# Part 5 Approval **ACCESS REPORT**

**Reference Number:** 22324

**Client:** Stanton Dahl Architects

**Site Address:** 71-73 Viccliffe Avenue, Campsie NSW

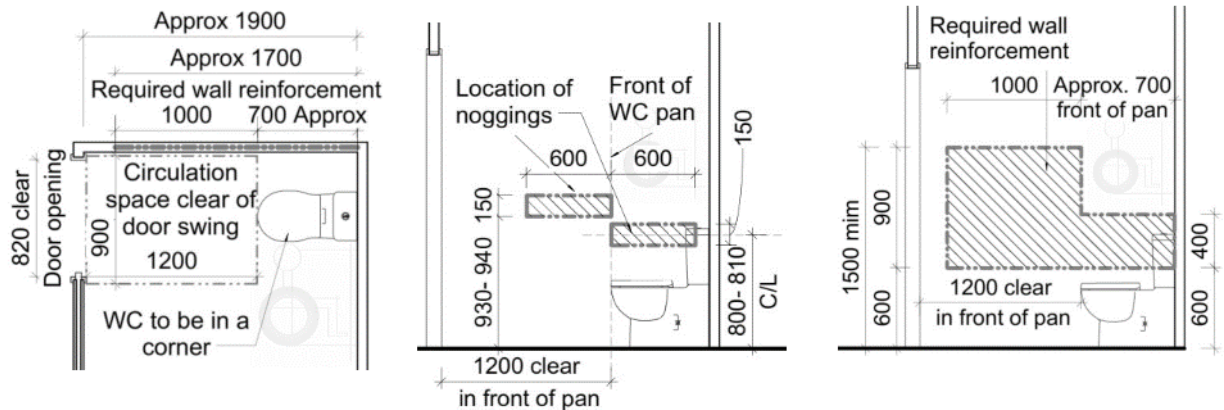
- a. Except for walls constructed of solid masonry or concrete, the walls around the shower, bath (if provided) and toilet should be reinforced to provide a fixing surface for the safe installation of grabrails.

Capable of compliance.  
Details to be verified at Tender stage of works

[Image description: Diagram shows wall reinforcements options of noggings or sheeting for a toilet]

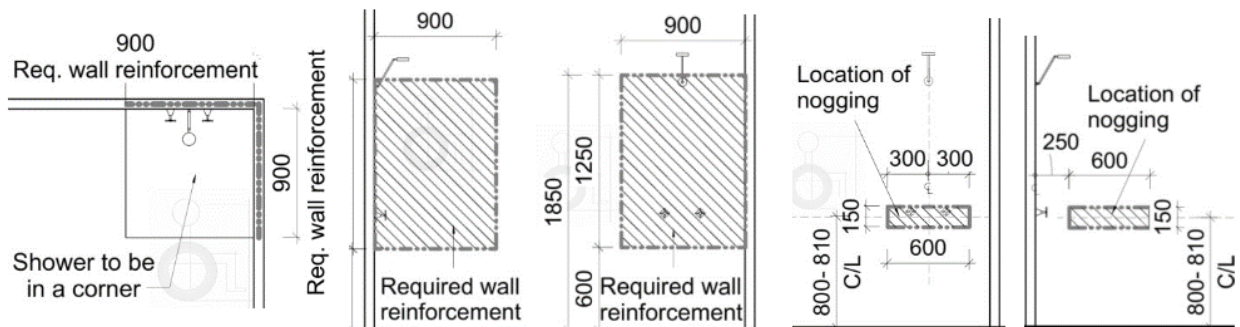
**Note:** In a standalone toilet, the wall reinforcements are required to both sides. Any door openings/ door frames are required to be clear of the required wall reinforcements. If wall with cavity slider is used for wall reinforcements, then allow for additional thickness for the wall.
